Docket Item #11
BAR CASE# 2005-0028

BAR Meeting
May 18, 2005

ISSUE: Addition and alterations

LOCATION: 309 South Lee Street

Figure 1 Proposed North elevation

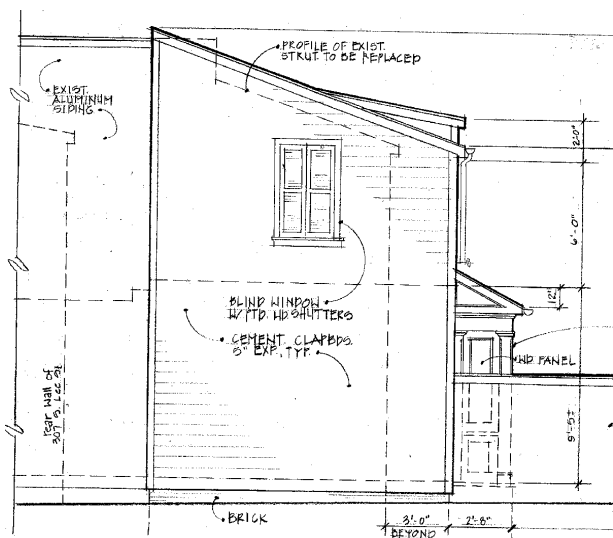
The north elevation, located along the property line will have a blind window located at the second story level with panelled wood shutters. The west elevation includes a one story bay measuring 3' in length by 9' in width. The bay will have three six-over-six windows above a single wood panel. The bay also includes decorative wood columns and a copper standing seam roof. Centered above the bay window at the second story is a through the cornice dormer with a pair of multi-light windows.

Staff believes that the proposed addition and alterations are appropriate. The alterations to the south elevation will only be minimally visible and will affect late 20th century alterations to the

Staff has no objections to the use of cementitious siding on the rear addition, which meets the Boards adopted policy for use of fiber cement siding.

Therefore, Staff recommends approval of the application with the following conditions:
